DATE: November 1, 2016
TO: Honorable Mayor and Council Members
FROM: John C. Gilbert, Village Manager
RE: Site Plan Review: 401 Hampton Ln.

DT: October 18, 2016
TO: John C. Gilbert, Village Manager
FR: Jud Kurlancheek, AICP, Director
Building, Zoning, Planning and Public Works Department
RE: Site Plan Review: 401 Hampton Ln.

Applicant	Village Manager
Request	Site Plan Approval for a park
Site Address	401 Hampton Ln.
Master Plan	Single Family Medium Density Residential.
Zoning District	GU Government Use
File Number	SP - 25
Recommendation	Approval

PERGOLA DETAIL

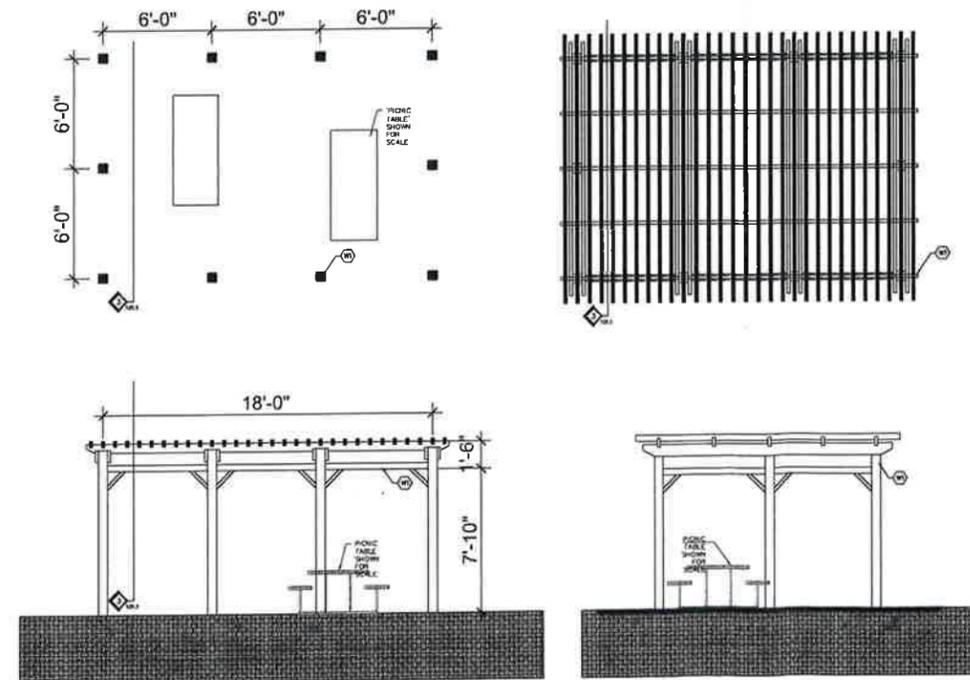
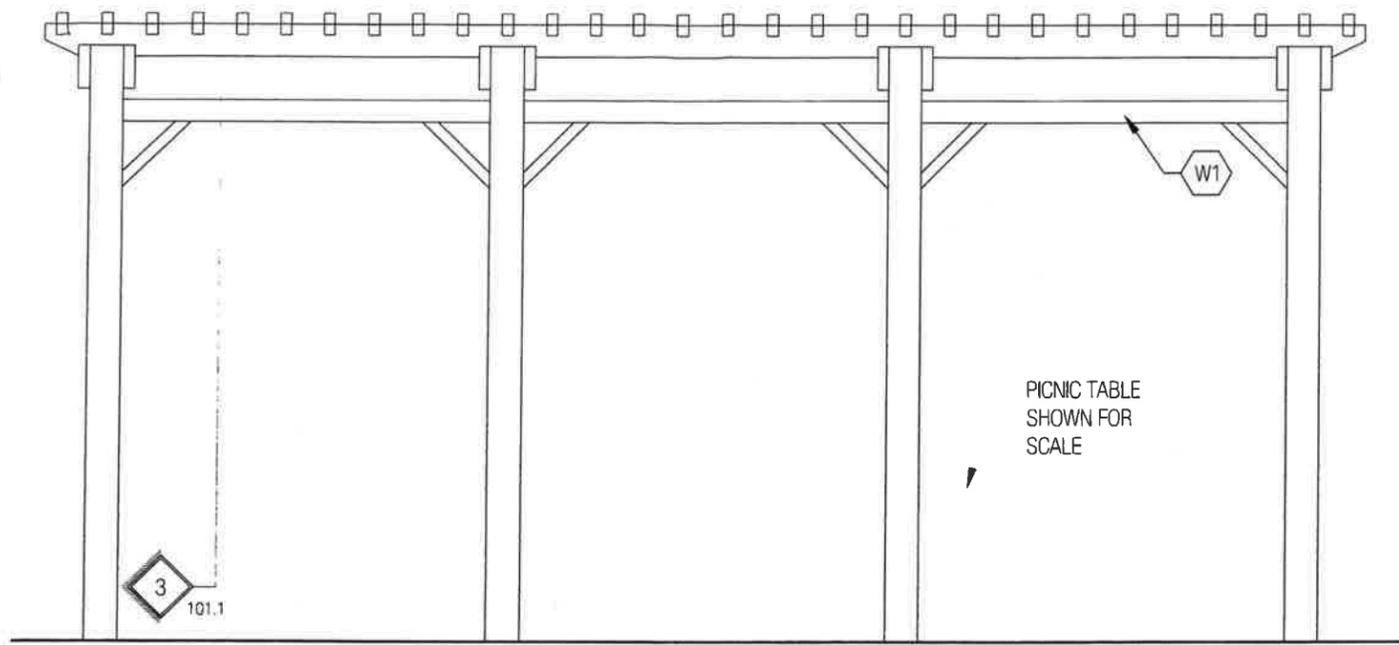
- a. The only building or structure is a pergola located inside the park near the pathway facing Hampton Ln. It will be wood, provide shade and be covered with landscaping. The location provides a view of the entire park. The style and texture of the pergola is found throughout the Village.
- b. The only building or structure is a pergola which measures 9 ft. 4 in. in height, 18 ft. long and 12 ft. wide from post to post. It is located inside the park near the pathway facing Hampton Ln. The pergola provides shade for two (2) pic-nick tables and an opportunity to observe activity in the park. It is open on all sides. There is an 8 ft. tall hill/berm that is located towards the center of the park which will be used by children. As such, there are no privacy issues.
- c. All signage will meet Village standards. There is no sign naming the park.
